Reference Sheet 789C OF 1204
Reference Note# 7

SFOBB SAS (SAS) Project #04-0120F4

Date: 2010-03-31
File Name: Risk Mitigation-East Saddle Anchor Rod

DETAIL A

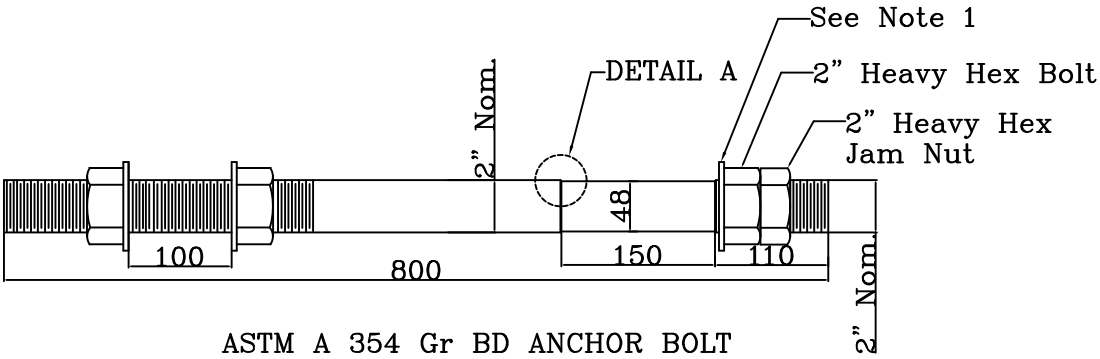
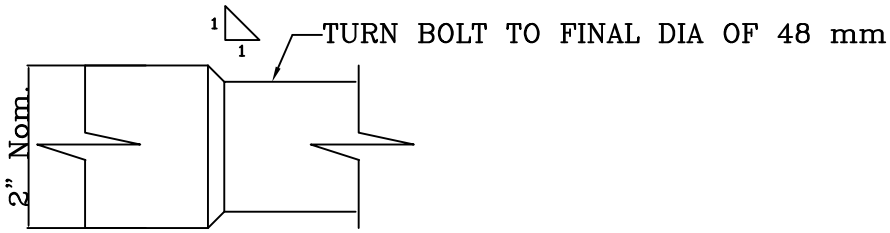
1. The Contractor shall ensure that the washer is located at the start of taper.

2. The Contractor shall apply organic zinc rich primer after machining.
